# Access Compliance Report

## Public Rights-of-Way

### (Curb Ramps)

Intersection ID: 11108	Main Street: TUCKASEEGEE_RD	Cross Street: N/A	Location: NE
ADA ID: 3364188CF46E	Ramp Type: Perp	Initial Pass/Fail: Fail	Overall Compliance: No
Codes/Mitigation Info/Possible Solution			Severity Score: 33.75
			Field Measurements/Component Compliance

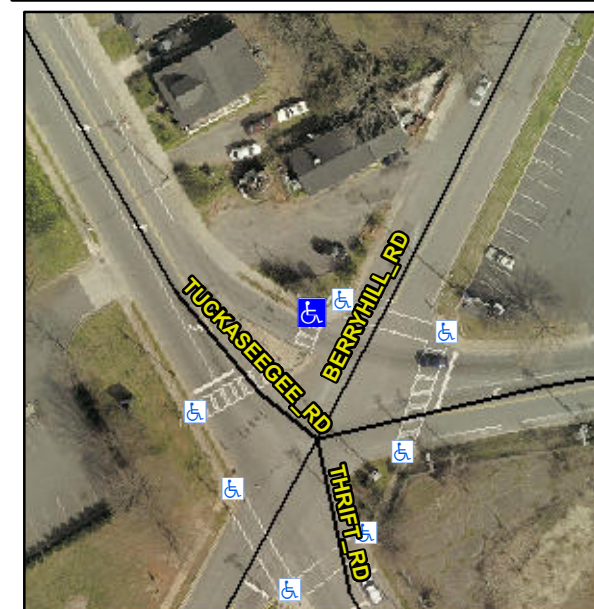
**Not Found, R304.5.1, R304.2.2, R304.5.3**

Compliance	Description	Data	Compliance	Description	Data
N/A	Ramp Length (in)	73.0	No	Ramp Slope (%)	11.5
No	Ramp Width (in)	46.0	No	Ramp XSlope (%)	5.7
N/A	Flare Type LT	N/A	N/A	Flare Type RT	N/A
N/A	Flare Slope LT (%)	N/A	N/A	Flare Slope RT (%)	N/A
N/A	Flare Traversable LT?	N/A	N/A	Flare Traversable RT?	N/A
N/A	Landing Length (in)	N/A	N/A	DWS Provided?	N/A
N/A	Landing Width (in)	N/A	N/A	DWS Contrast?	N/A
N/A	Landing Slope (%)	N/A	N/A	DWS Length (in)	N/A
N/A	Landing X Slope (%)	N/A	N/A	DWS Full Width?	N/A
N/A	Landing Curb? (Y/N)	N/A	N/A	DWS Offset (in)	N/A
N/A	Shared Landing?	N/A			
N/A	Gutter Ponding?	N/A	N/A	Gutter Slope (%)	N/A
N/A	Gutter Lip Ht (in)	N/A	N/A	Gutter X Slope (%)	N/A
N/A	Painted X Walk1?	Yes	N/A	Painted X Walk2?	N/A
	X Walk 1 Direction	To SW		X Walk 2 Direction	N/A
N/A	X Walk 1 Width (in)	111.0	N/A	X Walk 2 Width (in)	N/A
	X Walk 1 Slope (%)	7.0		X Walk 2 Slope (%)	N/A
	X Walk 1 X Slope (%)	2.7		X Walk 2 X Slope (%)	N/A

**Remove & Replace Entire Ramp.**
